APPLICATION NO.	FILING DATE	FIRST NAMED INVENTOR	ATTORNEY DOCKET NO.	CONFIRMATION NO.
10/526,337	03/02/2005	Kenichi Nakamura	NAKA0102PUSA	8947
22045 BROOKS KUS	7590 07/31/200 HMAN P.C.	EXAMINER		
1000 TOWN C			HUYNH, KHOA D	
TWENTY-SECOND FLOOR SOUTHFIELD, MI 48075			ART UNIT	PAPER NUMBER
			3751	
			MAIL DATE	DELIVERY MODE
			07/31/2008	PAPER

Application No.	Applicant(s)	
	10/526,337	NAKAMURA ET AL.	
Office Action Summary	Examiner	Art Unit	
	Khoa D. Huynh	3751	
The MAILING DATE of this communication ap Period for Reply	opears on the cover sheet with the	correspondence address	
A SHORTENED STATUTORY PERIOD FOR REPI WHICHEVER IS LONGER, FROM THE MAILING I - Extensions of time may be available under the provisions of 37 CFR 1 after SIX (6) MONTHS from the mailing date of this communication. - If NO period for reply is specified above, the maximum statutory period - Failure to reply within the set or extended period for reply will, by statu Any reply received by the Office later than three months after the maili earned patent term adjustment. See 37 CFR 1.704(b).	DATE OF THIS COMMUNICATIO .136(a). In no event, however, may a reply be tid d will apply and will expire SIX (6) MONTHS fr

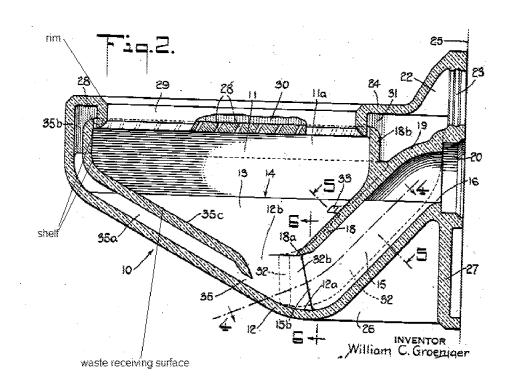
Regarding claim 1, the Groeniger reference discloses a flush toilet that uses a prescribed amount of cleansing water stored in a cleansing water tank to cleanse the toilet and discharge waste. The flush toilet includes a bowl (at 10) having a bowl-shaped waste receiving surface, a rim (see above illustrations)

constituting an upper edge portion whose inner surface overhangs inward and a shelf (see above illustrations) formed between the rim and the waste receiving surface (Fig. 2), and a drainage channel (at 15) whose inlet is connected to the bottom of the bowl for discharging waste. A first water spouting section (at 32a on the left side) for spouting cleansing water onto the shelf of the bowl to form a vortex; a second water spouting section (at 32a on the right side) for spouting cleansing water onto shelf of the bowl in the same direction as the swirling direction of the vortex; a first water channel (at 32 on the left side) for supplying cleansing water from the cleansing water tank to the first water spouting section; and a second water channel (at 32 on the right side) for supplying cleansing water from the cleansing water tank to the second water spouting section.

And lastly, as shown in the above illustration and stated in the above rejection, does discloses a flush toilet including a bowl (at 10) having a bowl-shaped waste receiving surface, a rim, a shelf (the above illustration show a structure resembles a flat structure extending from a surface 35c) formed between the rim and the waste receiving surface (Fig. 2), a first water spouting section (at 32a on the left side) for spouting cleansing water onto the shelf of the bowl to form a vortex; a second water spouting section (at 32a on the right side) for spouting cleansing water onto shelf of the bowl in the same direction as the swirling direction of the vortex.
